New Crosstown Park South

What We Heard: Concept Designs Virtual Public Meeting and Survey Summary Report

May 2021

Proposed concept design.

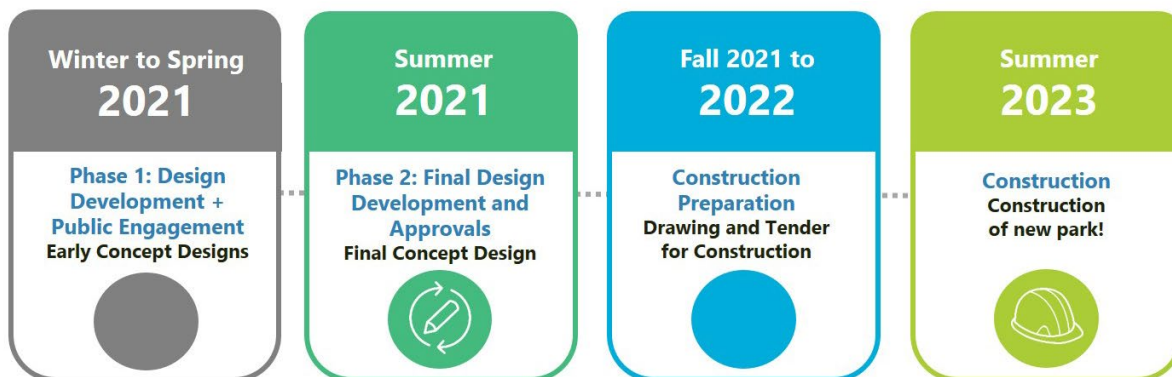
1. What are the proposed dimensions of the play area?

2. With the size and scope of this new park and nearby large development, how are unintended consequences related to litter/garbage and people making their own trails being handled by the design team and the City?

3. Can the location of the play area be located where the open lawn area is instead, to mitigate noise?

10. What will the walkway material be made of? Can it be made of wood?

Staff Comment: The size of the play area is 625 m².

Staff Comment: The new park will have waste and recycle receptacles which will be serviced by Toronto Solid Waste. There will be a designated "woodland" trail along the west boundary of the park and a paved circular pathway through the park. There will also be a switchback path leading from the park down to Eglinton Ave. municipal sidewalk.

Staff Comment: The play area is tucked back from the road on the North to

provide a sense of separation and to centralize the playground within the park. Additional planting has also been added to strengthen this separation and reduce noise.

Staff Comment: The design team will consider this feedback for the refined concept design. Wood will not be considered due to resilience considerations.

Concept | Plan

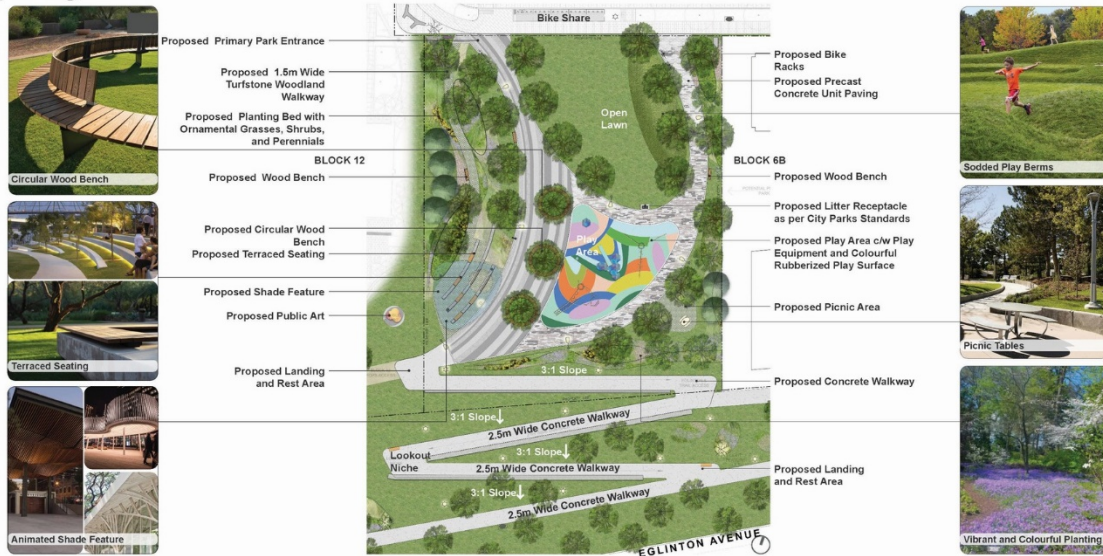
- Three major problems: The location is inaccessible and adjacent to a busy thoroughfare. It would be more appropriate adjacent to block 3a and 3b. The location has no parking area. Small toddlers are often brought to the area by car. eg. check out the participation at our recently installed play area at Concorde Place on the McDonald's site. A Major deficiency is the lack of a W.C. on or adjacent to the site.

- Drainage for rain, and snow, especially around play areas. Tunnels may not be a good idea due to security concerns? Ideally most of the facilities can be accessible for all seasons, rain or snow.

- Shade trees are very important with the hot summer south exposure. The plan looks like it has just one waste/recycle receptacle location - they should be at every access point. There is some lighting shown on the plan - it would be good to see details of the proposed fixtures and the overall lighting strategy. The switchback walkway is great for mobility access and for meandering, but it would be good to have a set of stairs connecting them on the west side to provide a choice for an express connection

up/down the slope. I think there will be times when the park will be used more as a pass through between Eglinton Ave. and the Crosstown neighbourhood in general.
